CCK-2669-23 ADDENDUM# 1 11/23/2022

UK Indoor Track Facility

CCK-2669-23 Indoor Track JRA Project No. 202258 UK Project 2584.0 University of Kentucky Lexington, Kentucky

The Addendum will form a part of the Contract Documents and modifies the original Bidding Documents dated October 2022.

Attachment A – REVISED Site Logistics plan.

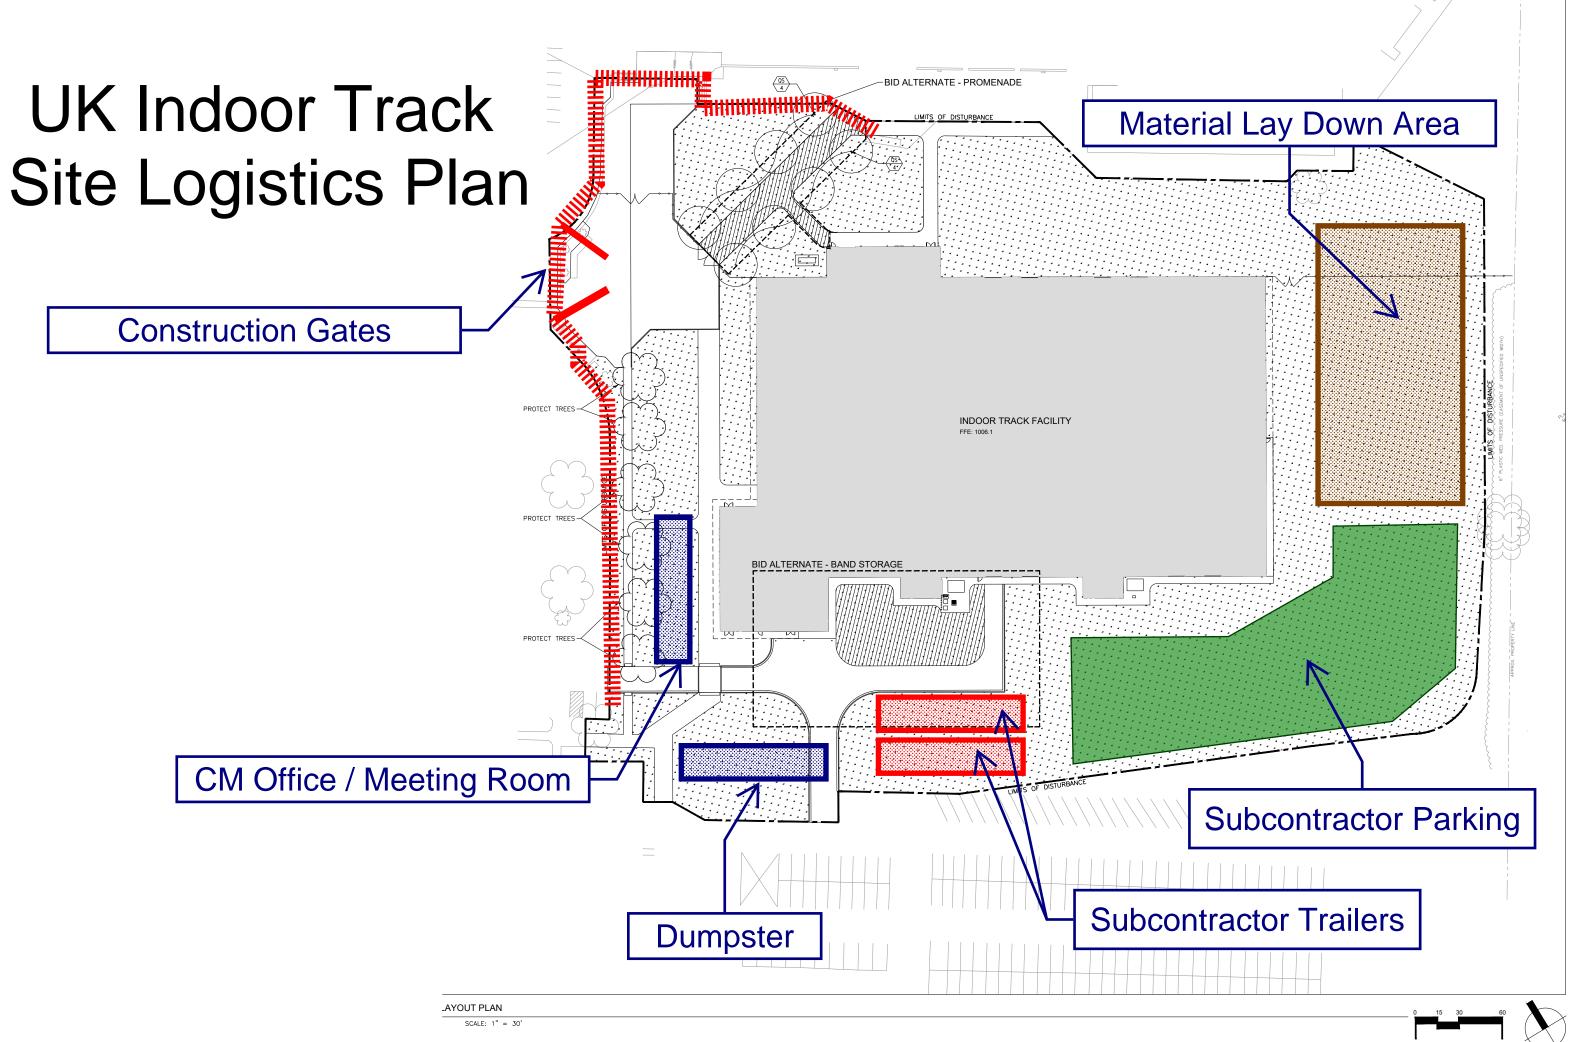
B-1) Attached to this addendum is the REVISED Site Logistics plan. Much of the site perimeter has existing fencing that will remain. The requirement for temporary fencing shall be reduced to only the area defined by the dashed line on the site logistics plan.

DRAWING INDEX

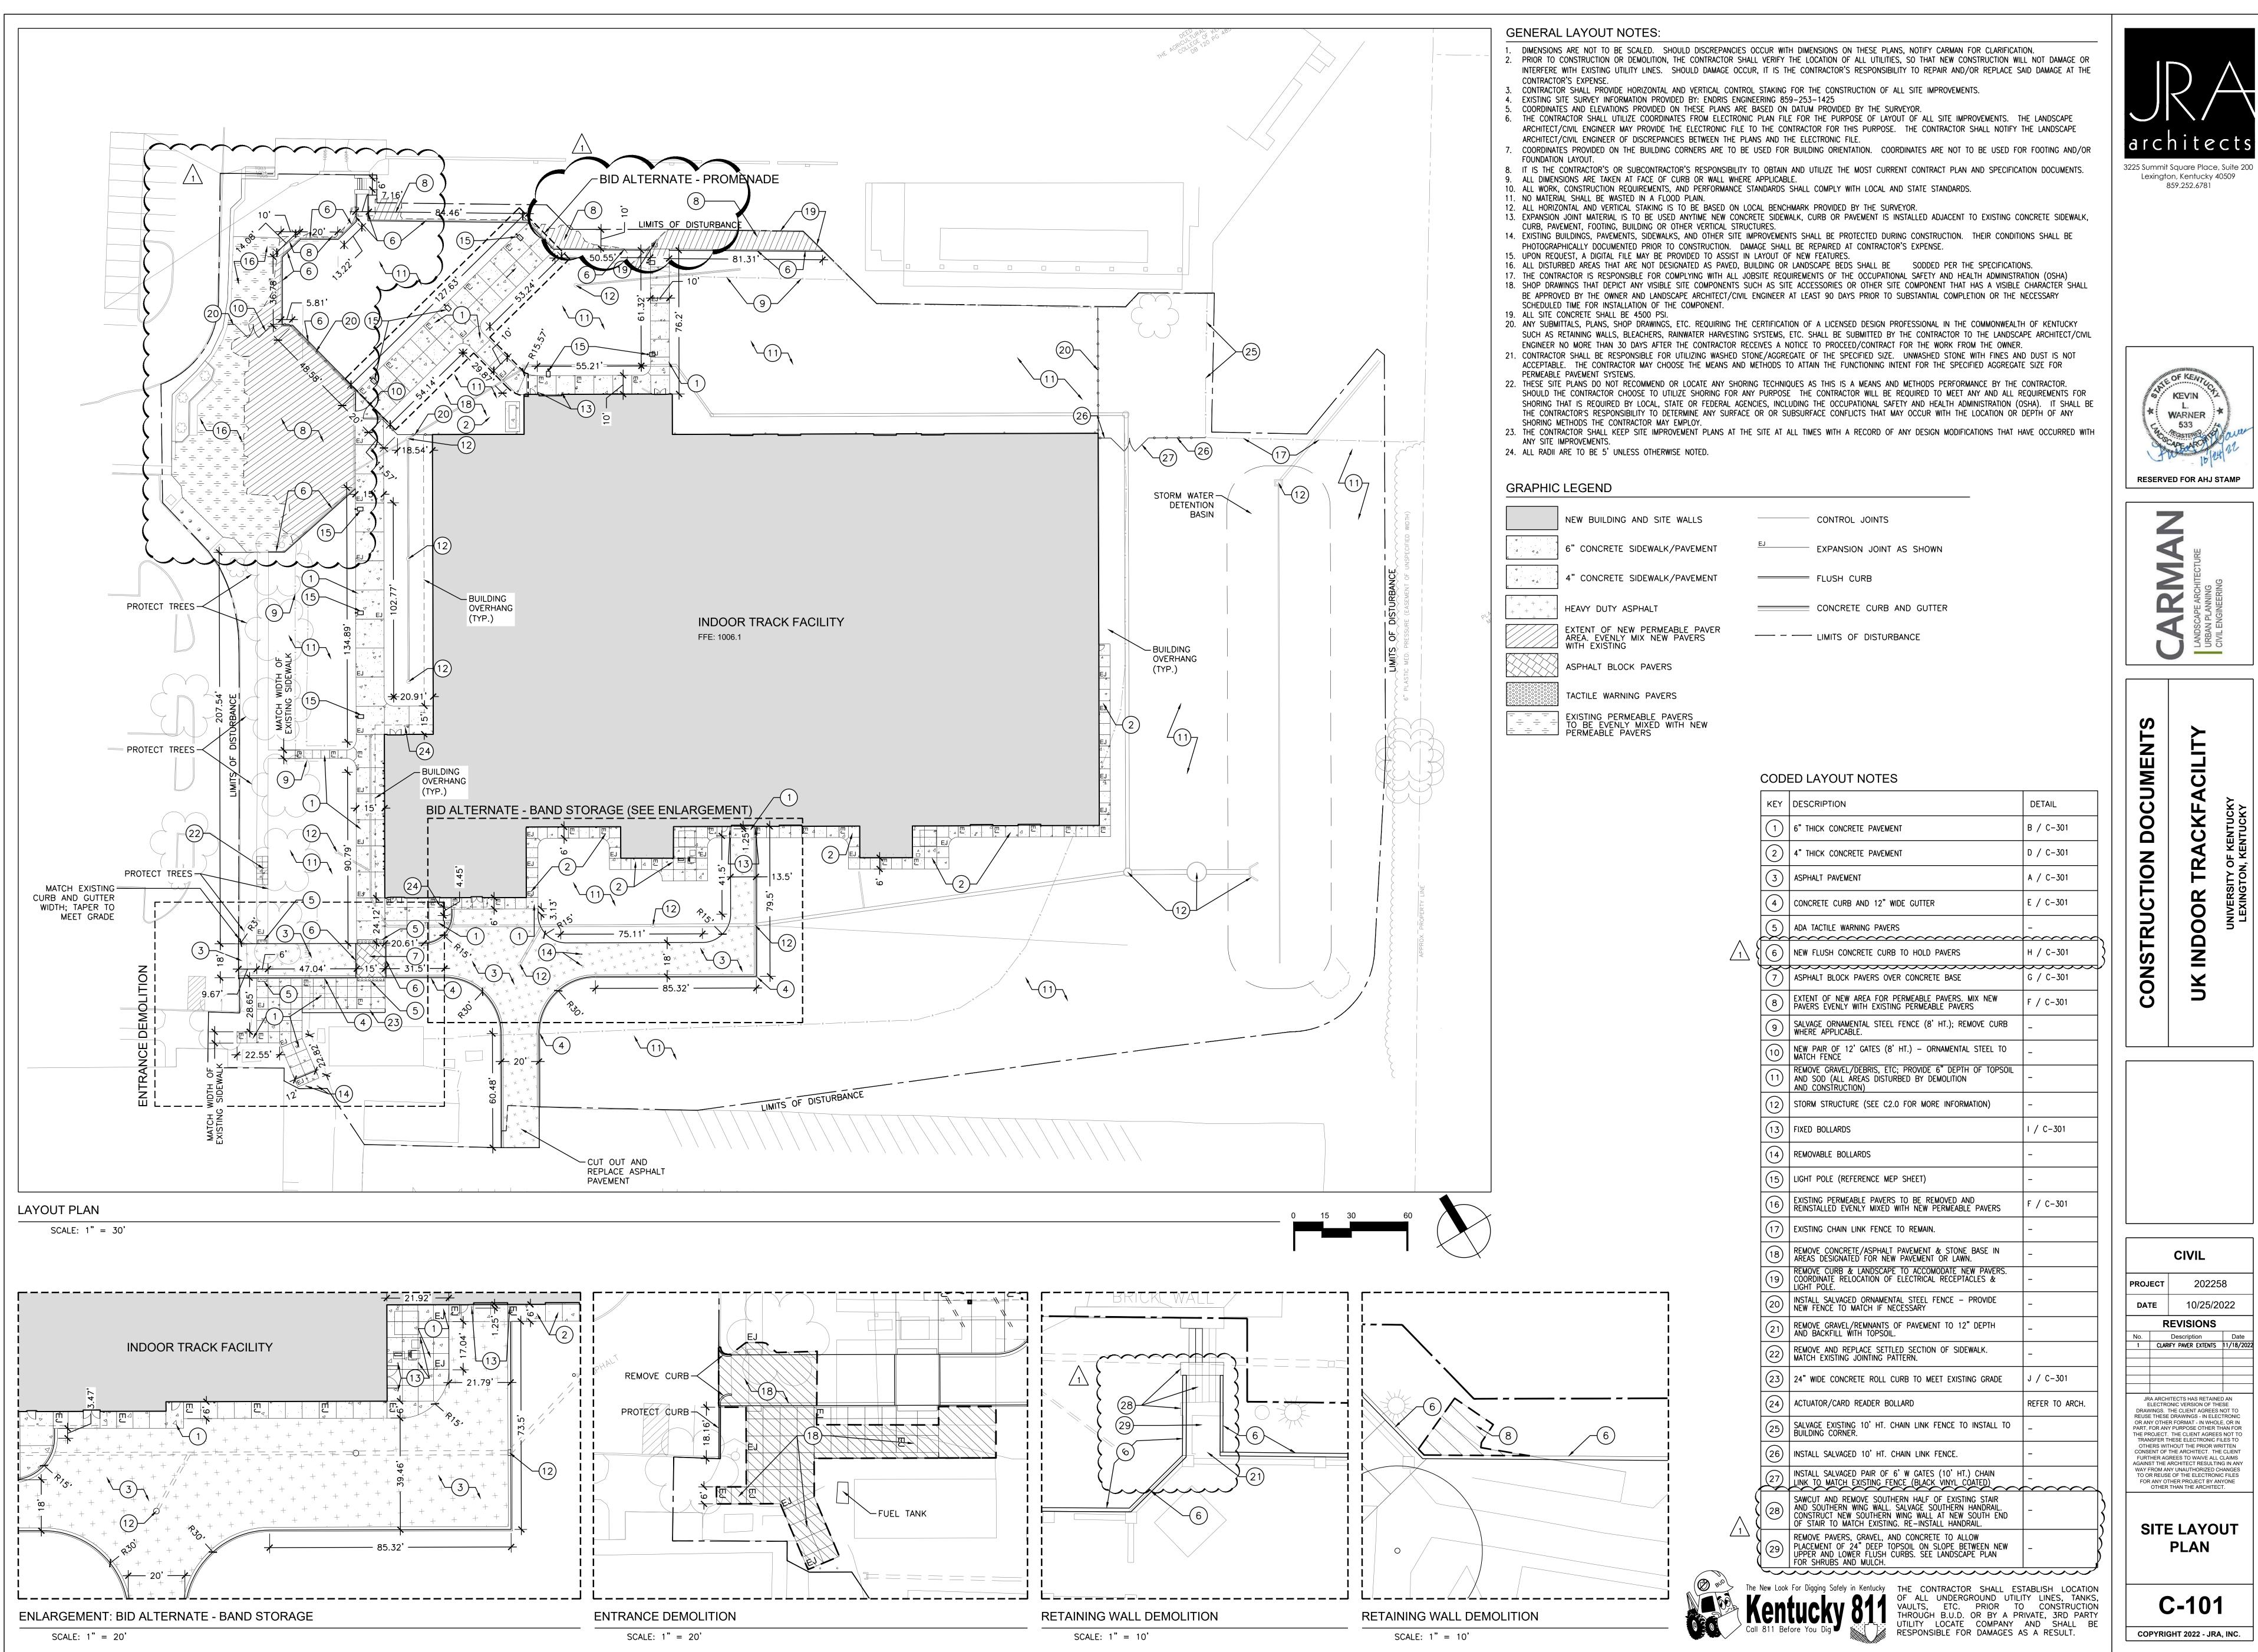
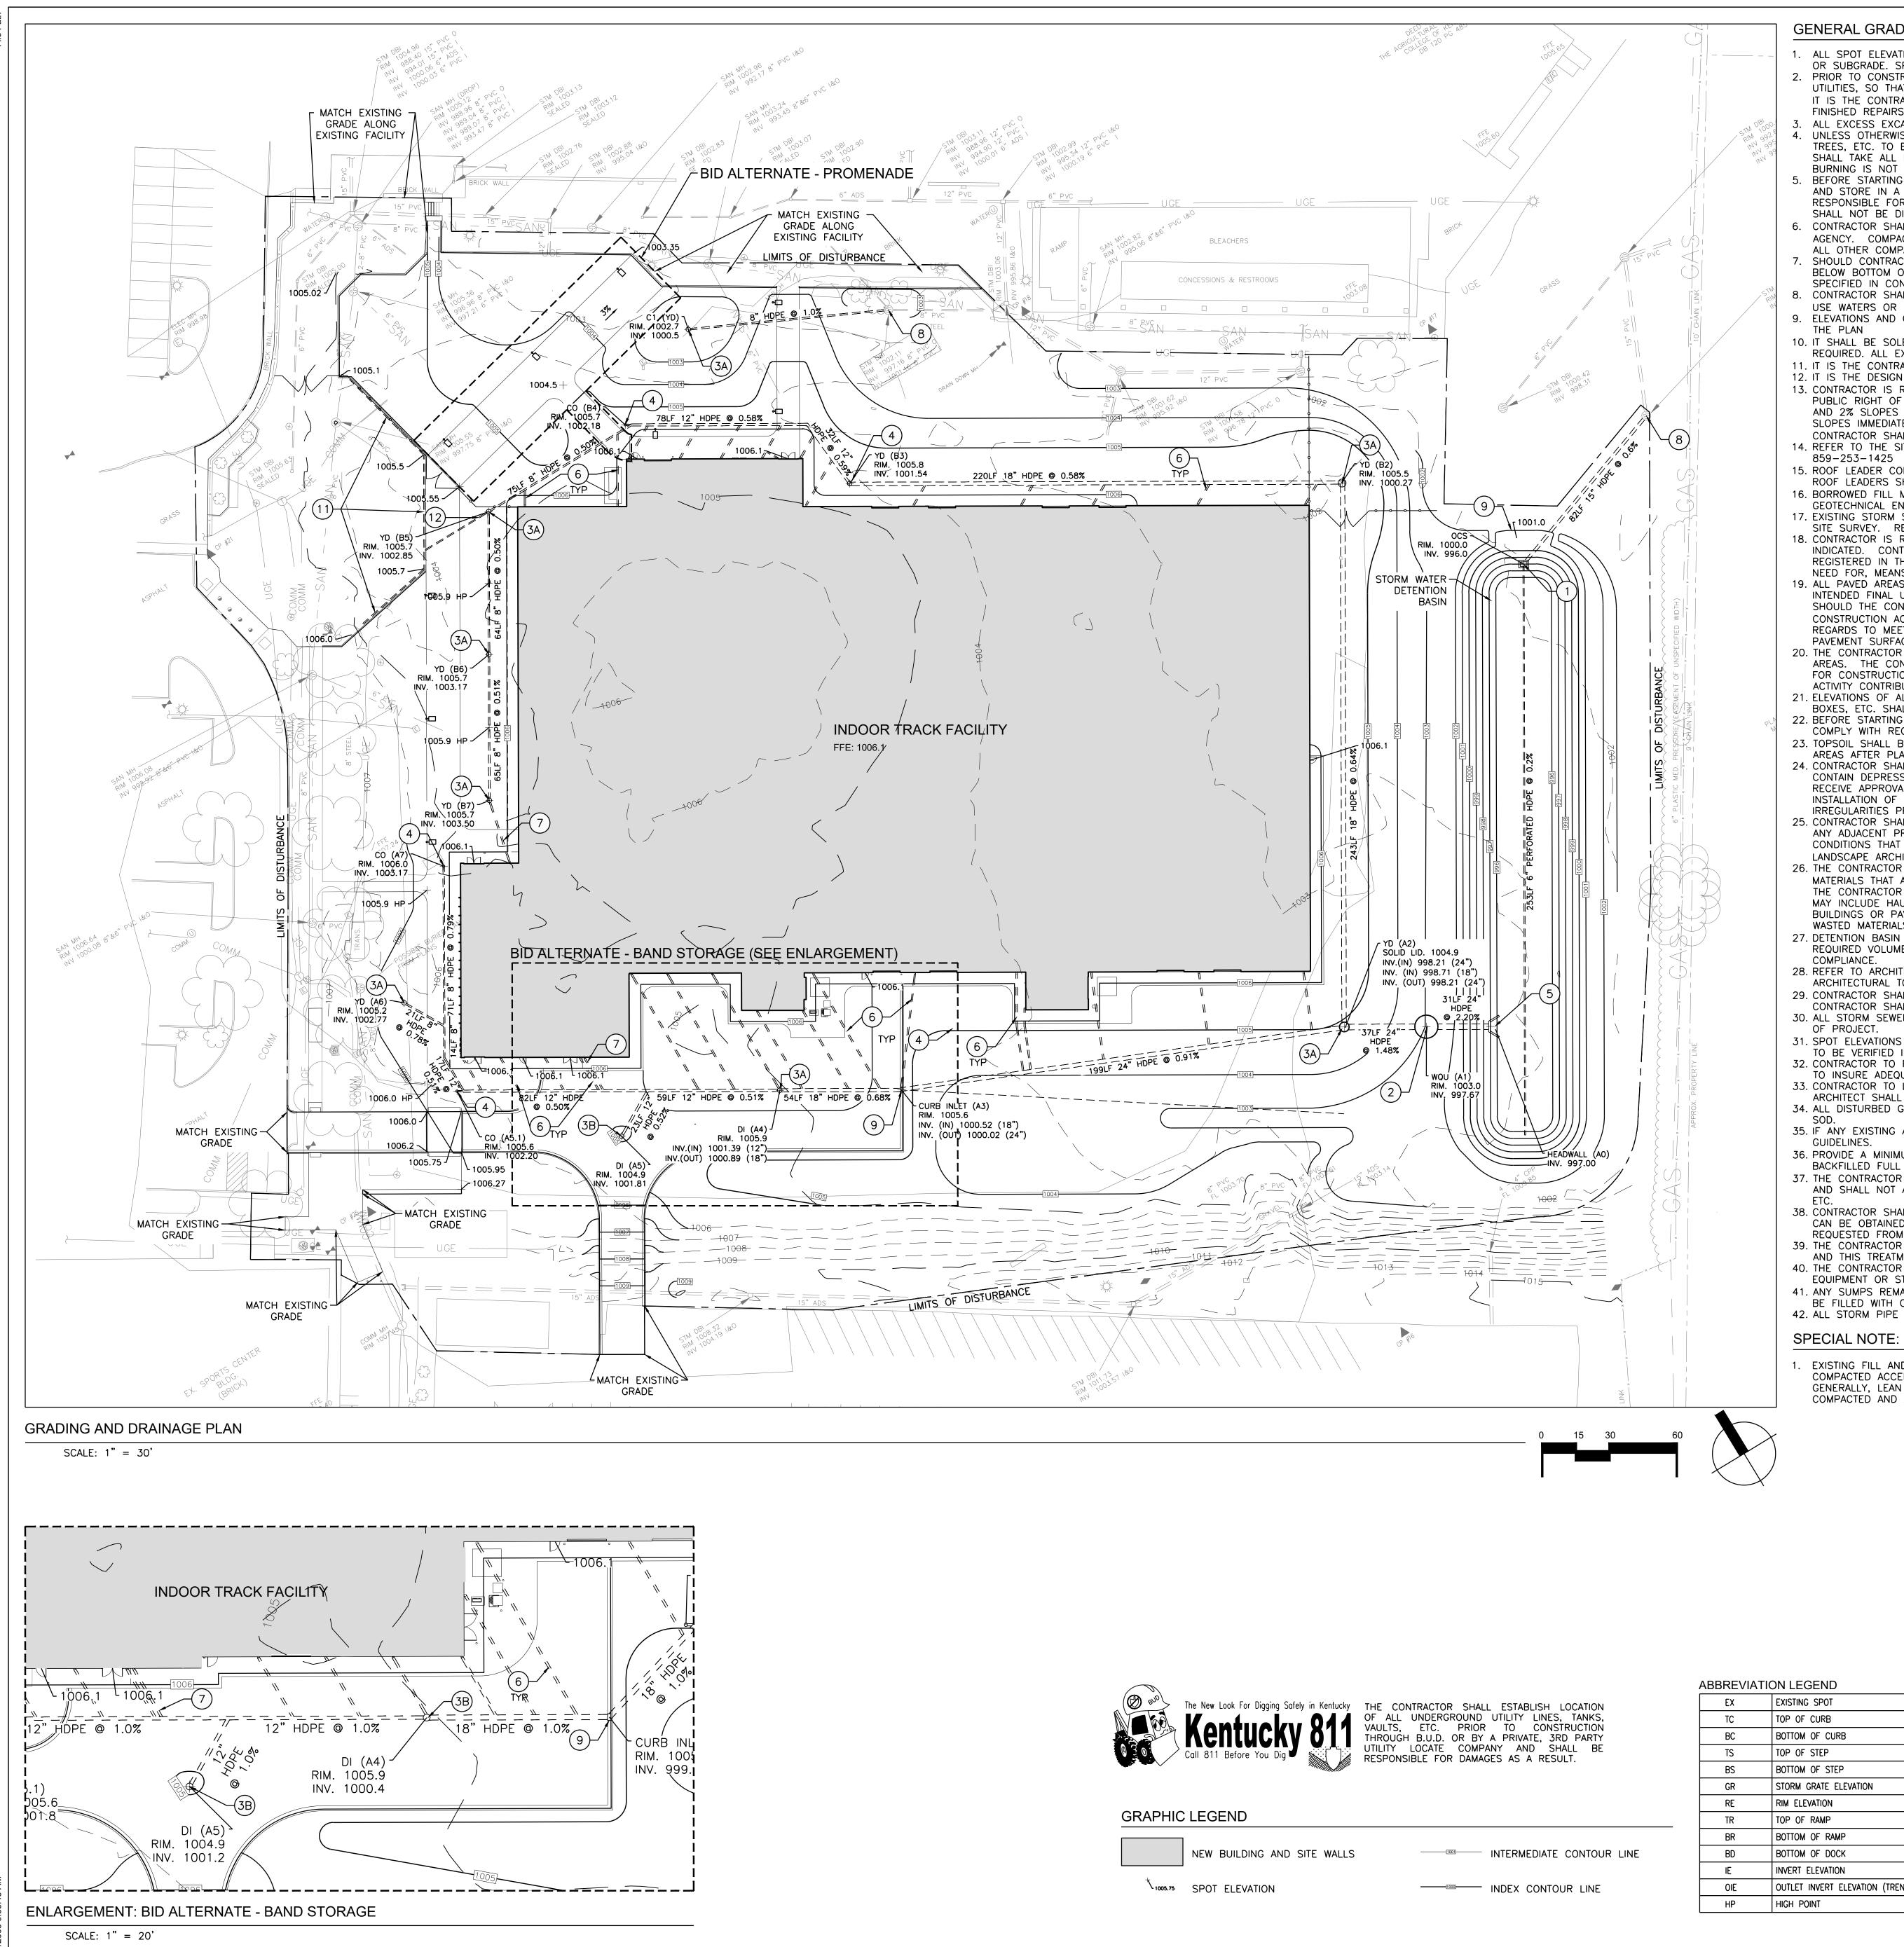
Refer to revised sheet G-001 Cover Sheet. Sheet C-303 added to drawing index.
